Product Change Notification: CENO-17QOYU860

CCB 8255 Final Notice: Qualification of MTAI as an additional final test site for ATAES132A-MAHER-T, ATAES132A-MAHEQ-T, ATAES132A-MAHER-S and ATAES132A-MAHEQ-S catalog part numbers (CPN) available in 8L UDFN (2x3x0.6mm) package.

CCB 8255
Pre and Post Change Summary
PCN #: CENO-17QOYU860

T/R - Cover Tape

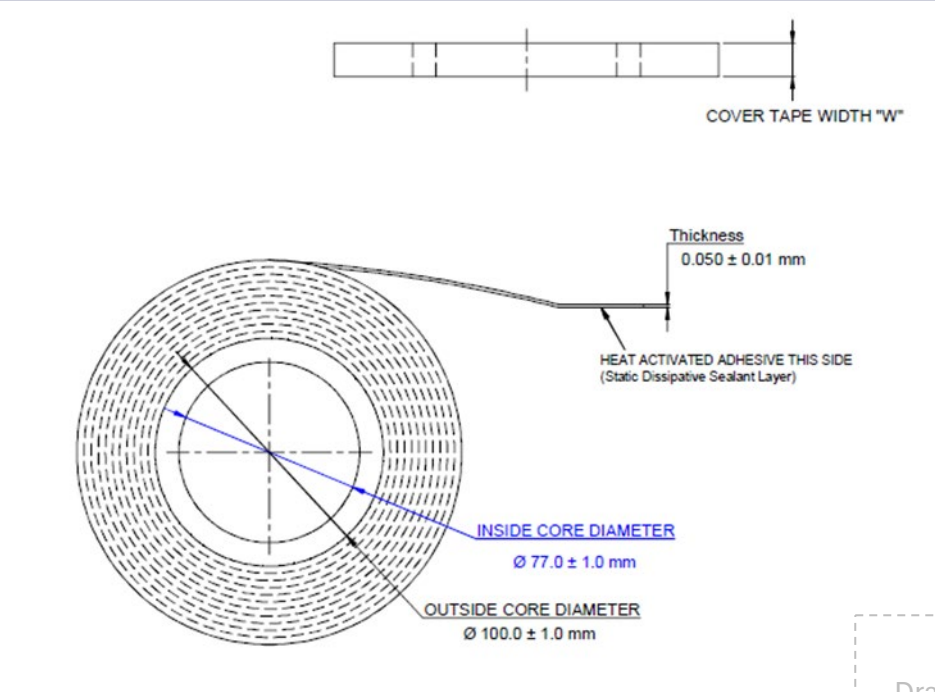
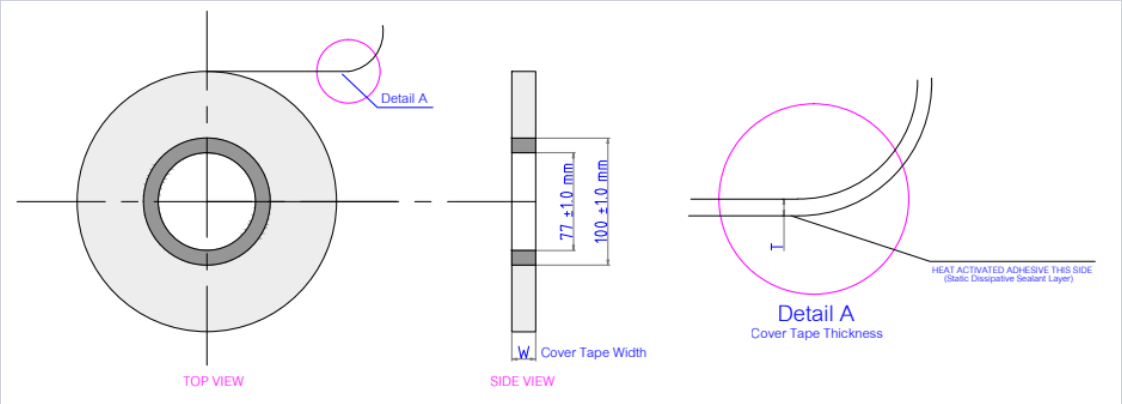
PLANT	WIDTH (mm)	THICKNESS (mm)	COLOR	SEALING METHODOLOGY
ASEK	5.4	0.050+/-0.010	Clear	Heat sealing
MTAI	5.4 ±0.1	0.050 ±0.010	Clear	Heat sealing

T/R - Plastic Reel

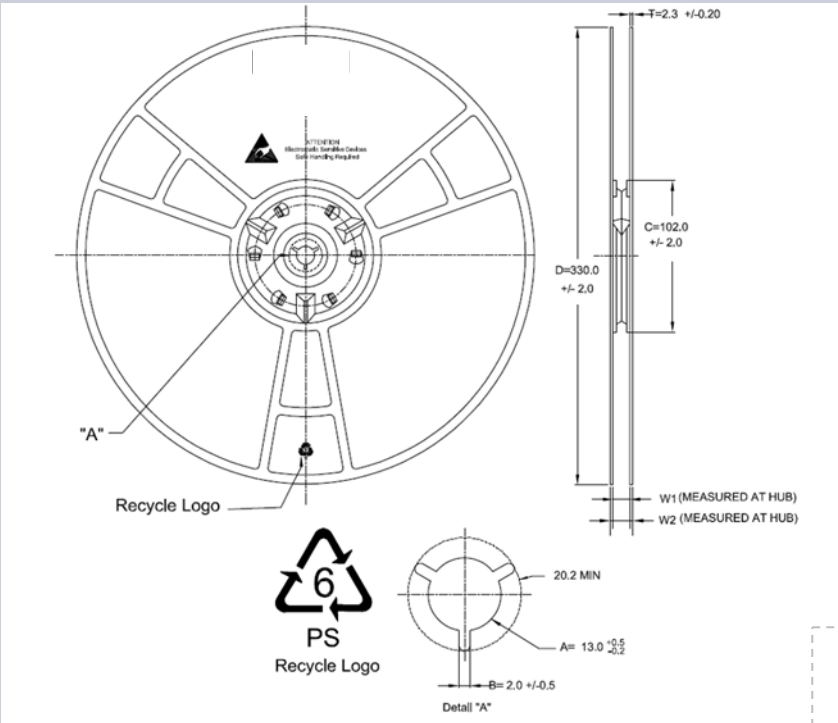
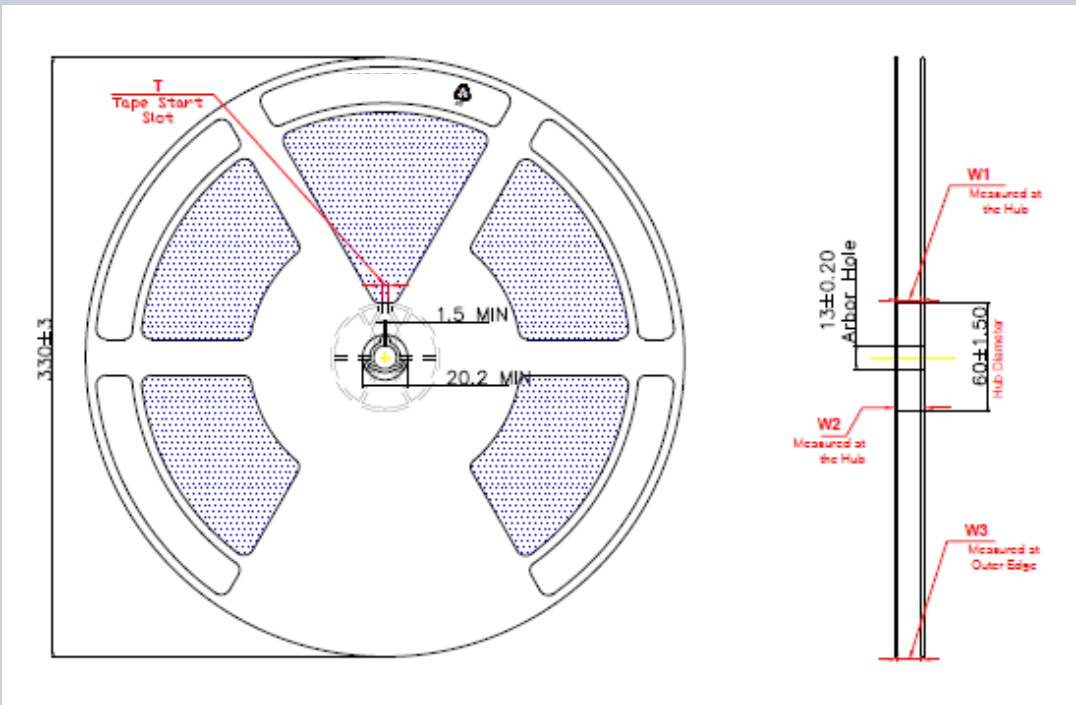
PLANT	REEL DIAMETER (mm)	REEL HUB SIZE (mm)	REEL WIDTH MAX (mm)	COLOR
ASEK	330	102	14.40	White
MTAI	330 $\pm$ 3.0	60 $\pm$ 1.50	14.40	White

T/R - BAG

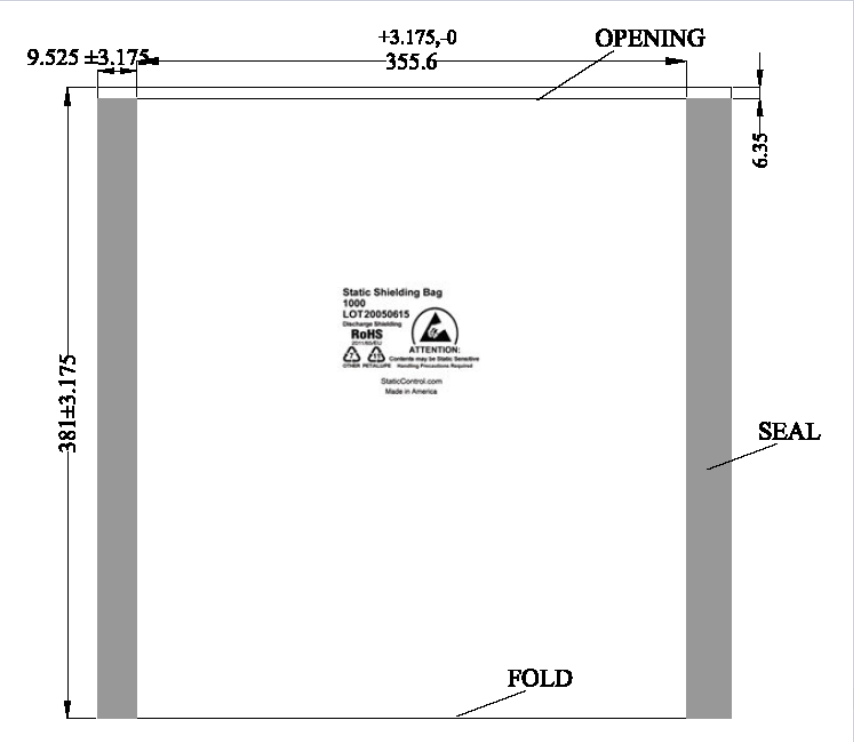
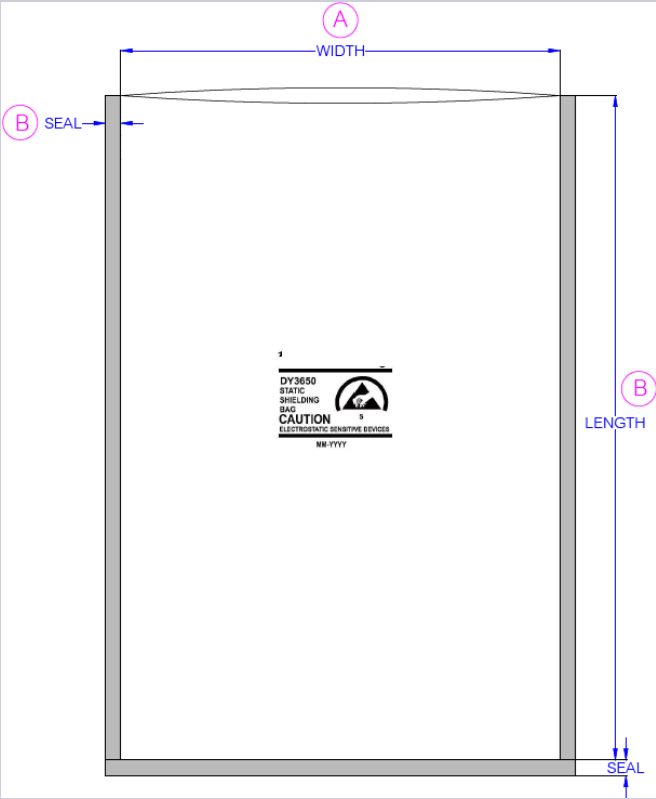
PLANT	BAG TYPE	LENGTH (mm)	WIDTH (mm)	THICKNESS (mm)
ASEK	Static Shielding Bag	381 +/- 3.175	355.6 + 3.175/-0	0.07
MTAI	Static Shielding Bag	420 +5/-0	370 +5/-0	0.0762
